23-31 Dover Road, Rose Bay

SSD-86017721 Submissions Report

May 2026

Prepared for: Dover Street (Rose Bay) Developments Pty. Limited

Figure 6 Rooftop communal open space plan

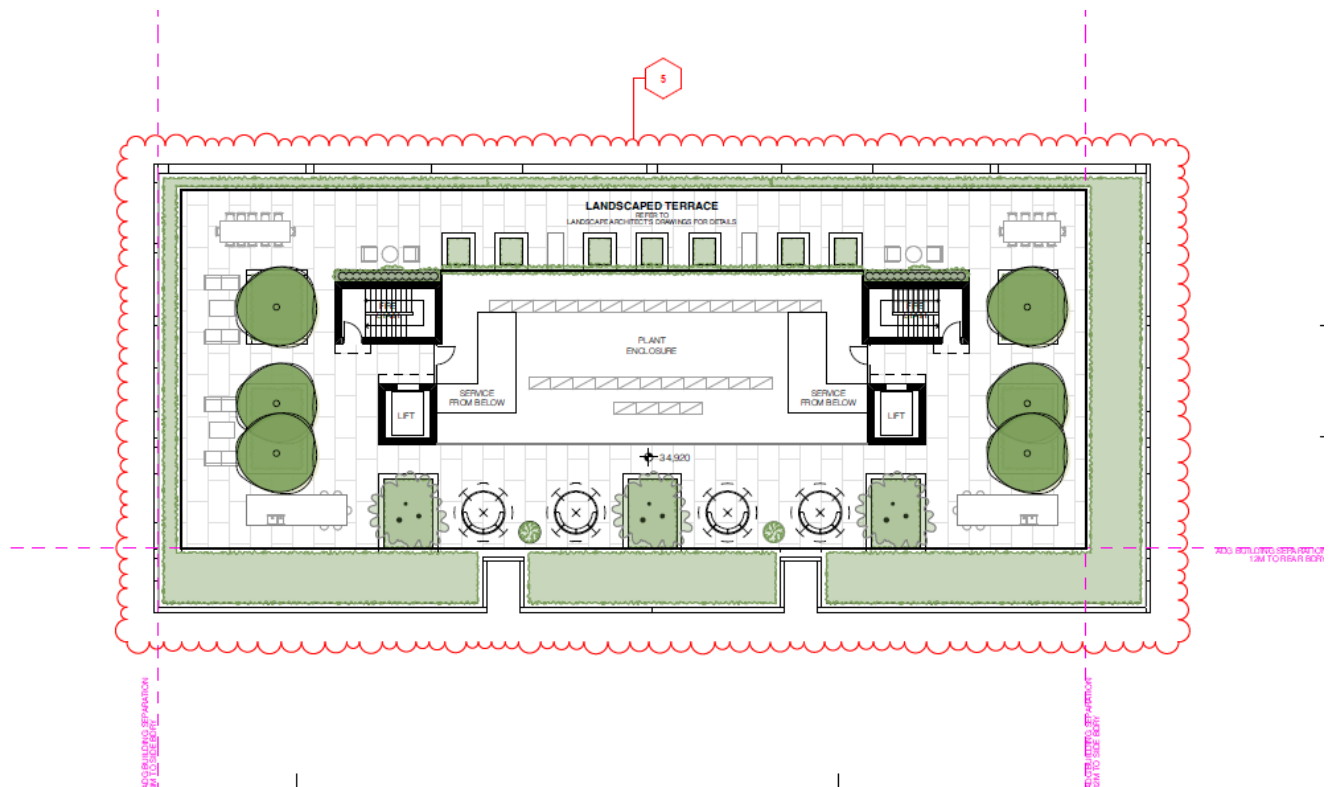
30. Provide shade structures to the rooftop open space to provide sun shading in summer months.	Additional sun shading has been incorporated into the rooftop open space through a combination of landscaping, tree canopy planting and parasols. Refer to the updated Architectural Drawing DA2010 for details.

The rooftop open space (561sqm) is provided in addition to the community garden located on the western side of the development (86sqm) and both of the forecourts (162sqm, representing 6% of the site). The DPHI has requested that the forecourts and garden are excluded from the communal open space calculation, reducing the provision from 808.4sqm (30% of the site area) to 561.32 (21% of the site area). These areas remain part of the design to provide and will still provide genuine and functional communal open space. Refer to Item 3 of the Cover Letter for more information.

Figure 9 Deep Soil Provision

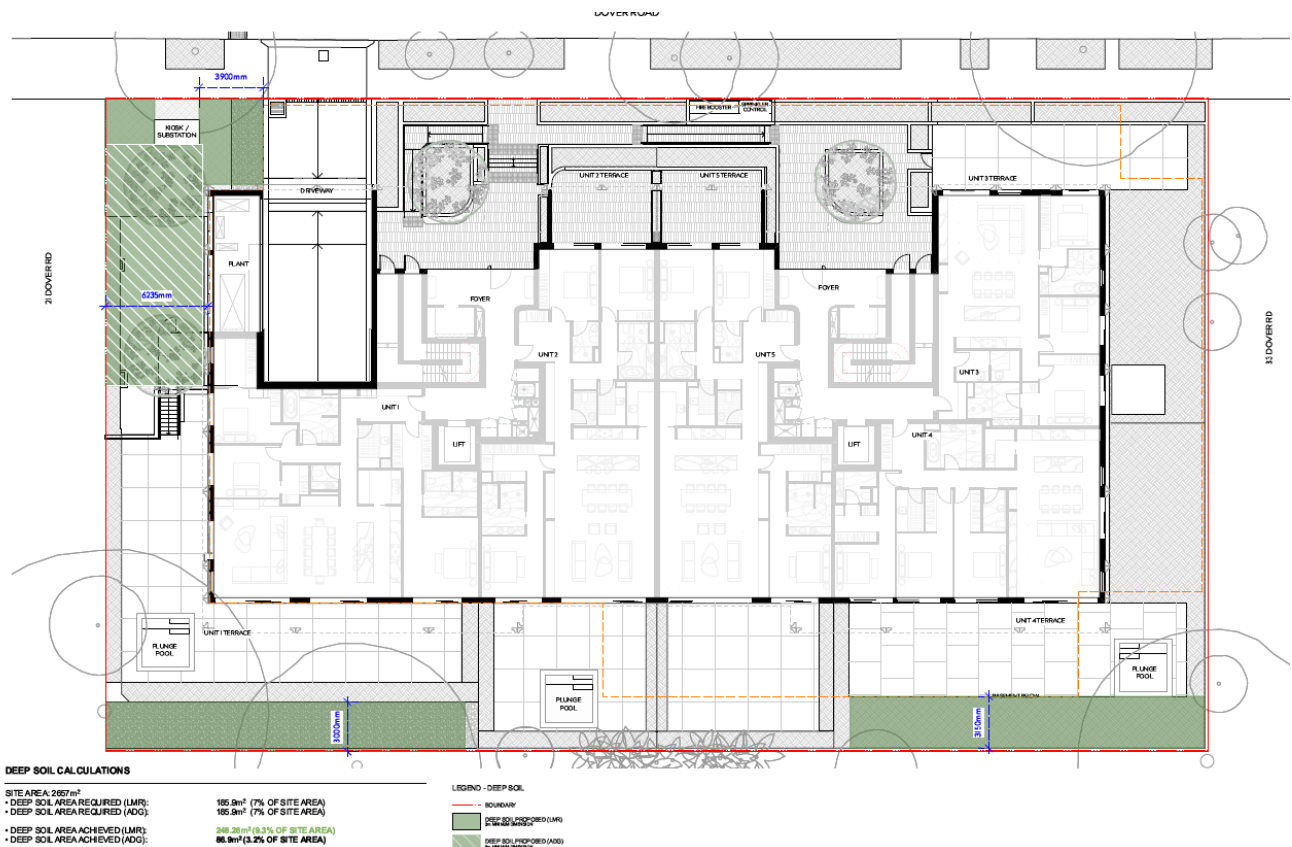
- Required: 7%, measured at a width of 6m (185.9sqm)
- Proposed: 3.2% (86.9sqm)

When assessed against the deep soil provisions of the Tree Canopy Guide for the LMR Housing Guidelines, the proposal demonstrates compliance. The deep soil provision under the ADG has also improved from the lodged design, increasing from 2.7% to 3.2%. Refer to Figure 9 for more details.
